**Raspberry Falls Raw Water Main
Addendum 1**

January 27, 2011

PROJECT: Raspberry Falls Raw Water Main
Project ID Number 20100094

ENGINEER: Urban, Ltd.
4200-D Technology Court
Chantilly, VA 20151

CASING INSTALLATION

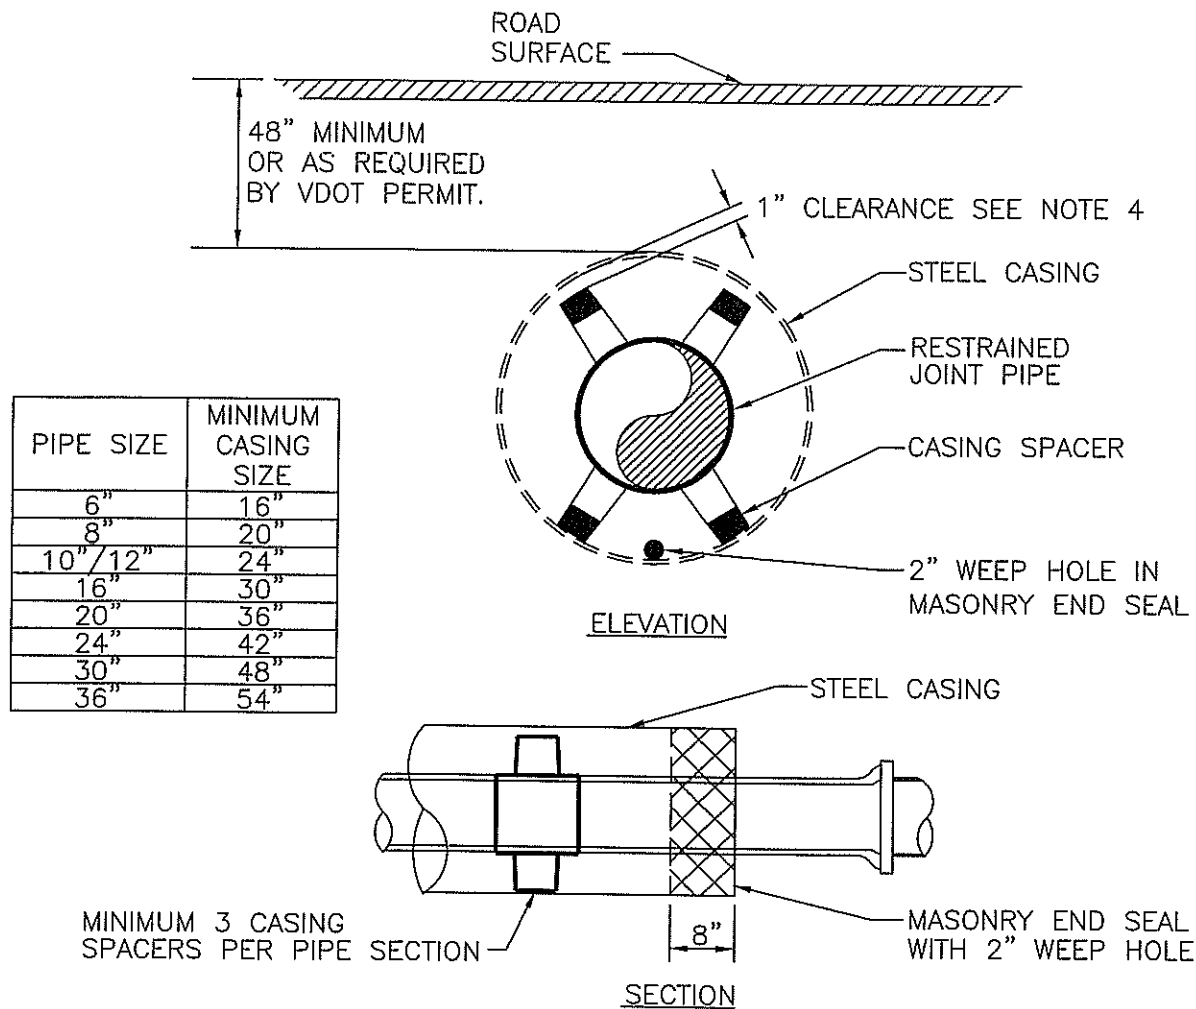
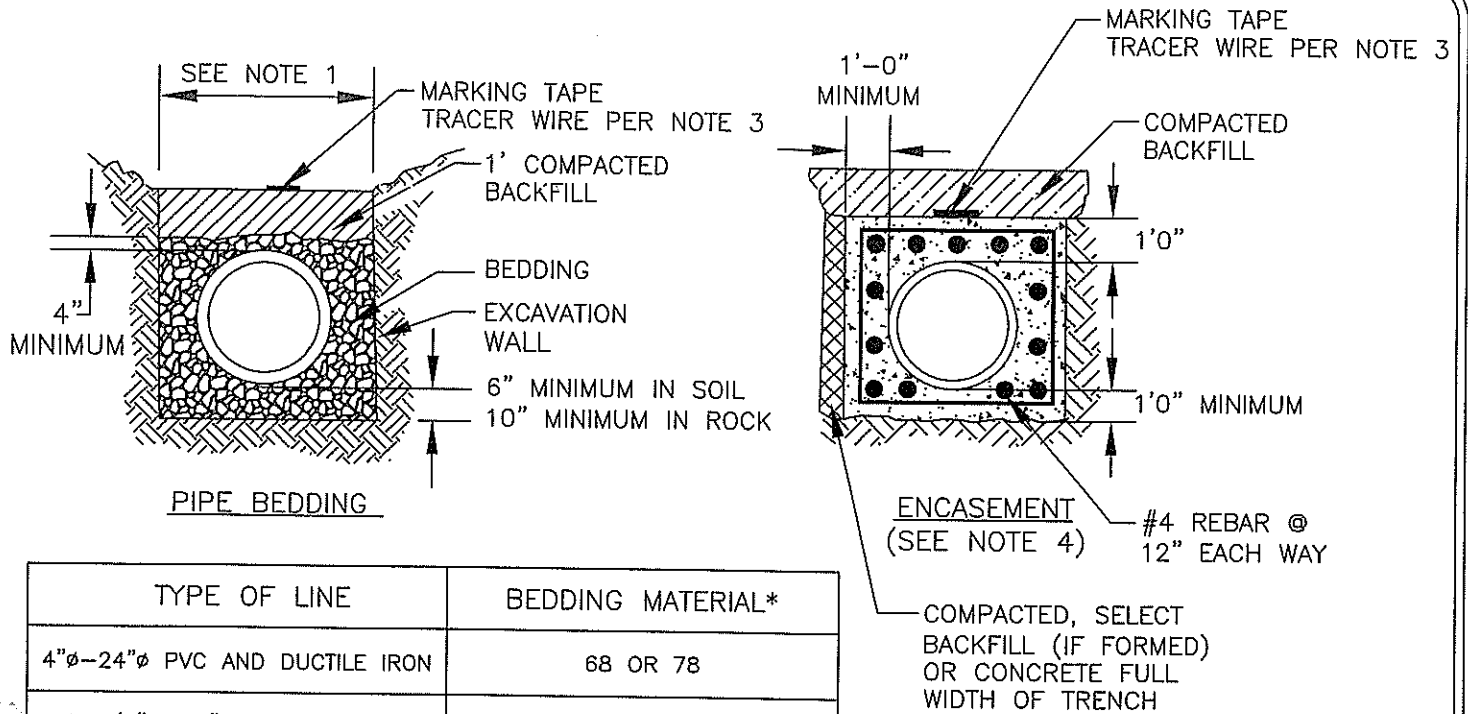
1. Urban Sheet 2 of 8 - Disregard 24" CL III RCP callout in VDOT Pavement Replacement Detail. Steel casing will be utilized per Loudoun Water Engineering Design Manual Detail G-12 "Casing Installation"

2. Urban Sheet 4 of 8 – The plan view of the existing wells PW-2 and PW-3 are called out backwards.
3. Urban Sheet 8 of 8 - Include from Loudoun Water Engineering Design Manual Detail G-12 "Casing Installation" In addition, the 4" DIP will receive a 16" casing.
